PLC-ARMOUR-P2738-001-TPR-Disposition Response Letter-1

Subject: Project 903 Battery Energy Storage System – Response to Dispositions

PLC Fire Safety Engineering (PLC) has completed a review of the responses to the Third-Party Review (TPR) of the Hazard Mitigation Analysis Report for the above-captioned project. The original review, documented in report # PLC-ARMOUR-P2738-001-TPR-C, dated May 15, 2025, identified nine (9) clarification items.

DISPOSITION OF FINDINGS

Figure 12
Single sided non-walk in enclosed switchboard

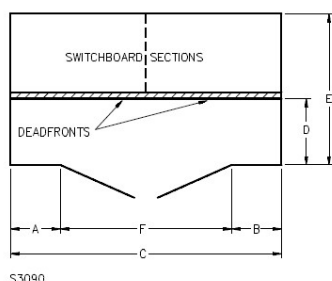
- The EVLOFLEX is not a walk-in unit
- The EVLOFLEX is within the maximum dimension described by NFPA 855 9.5.2.4.1 and is non considered a building as per 9.5.2.4.2
- All equipment and accessories that may require maintenance are accessible without stepping into the equipment, including the batteries themselves
- Non-walk in requirements are described in figure 12 of UL 891, referred to by UL9540 (see image bellow). The EVLOFLEX complies as a non-walk in enclosure.
